30-045-21301 REESE MESA #004

HILCORP ENERGY COMPANY

PLUG AND ABANDONMENT PROCEDURE

Reese Mesa #4 Proposed P&A

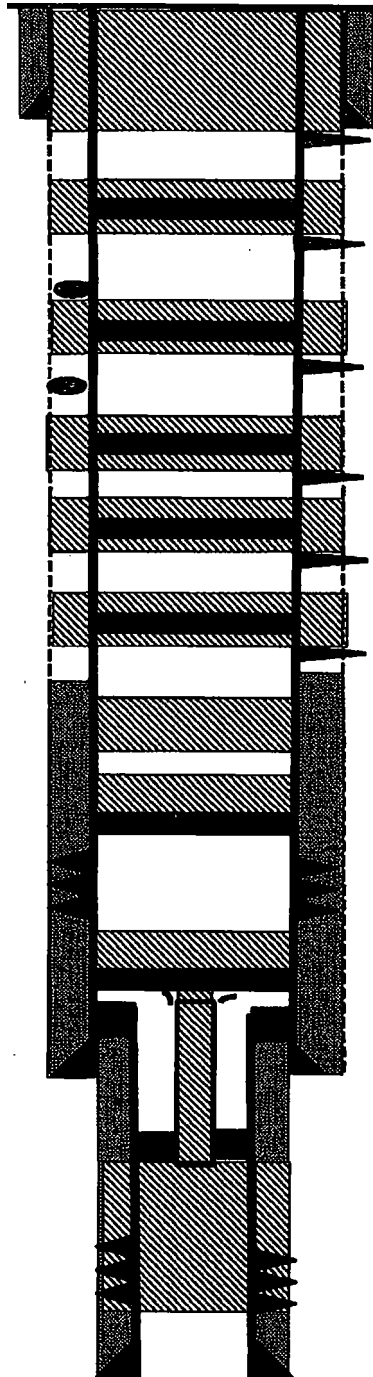
- Notify NMOCD 24hrs prior to beginning operations.
- Extend the Mesaverde Plug 6080'-5892'. OCD top:6030'
- Extend the Chacra Plug 4841'-4720'. BLM top: 4791' OCD top: 4770'
- Extend Pictured Cliffs Plug 3933'-3790'. BLM top: 3883' OCD top: 3840'
- Extend Fruitland Plug 3595'-3469'. BLM top: 3513' OCD top: 3545'
- Extend Kirtland/Ojo Alamo plug 3495'-2205'. BLM Kirtland top:2428' OCD Kirtland top: 2445'. BLM Ojo top: 2368' OCD Ojo top: 2255'

3. CBL required after setting CR@5992' from 5970' to surface to confirm TOC. Submit electronic copy of the log for verification to the following addresses: jkillins@blm.gov and Brandon.Powell@state.nm.us . Based on CBL results inside/outside plugs and volumes will be adjusted accordingly. Please review the General Requirements document to ensure all volumes meet required excess inside and outside casing.

4. The following modifications to the plugging program:
 - a. Plug 3: BLM picks top of Chacra at 4791'. Required top of plug 4741'
 - b. Plug 4: BLM picks top of Pictured Cliffs at 3883'. Perforate at 3933'. Set CR at 3883'. Required top of plug 3833'.

- c. Plug 5: BLM picks top of Fruitland at 3513'. Perforate at 3563'. Set CR at 3513'. Required top of plug 3463'.
 - d. Plug 6: BLM picks top of Kirtland at 2428'. Perforate at 2478'. Set CR at 2428'. Required top of plug 2378'.

- e. Plug 7: BLM picks top of Ojo Alamo at 2368'. Perforate at 2418'. Set CR at 2368'. Required top of plug 2318'.
 - f. Plug 8: BLM picks top of Nacimiento at 1322'. Perforate at 1372'. Set CR at 1322'. Required top of plug 1272'.
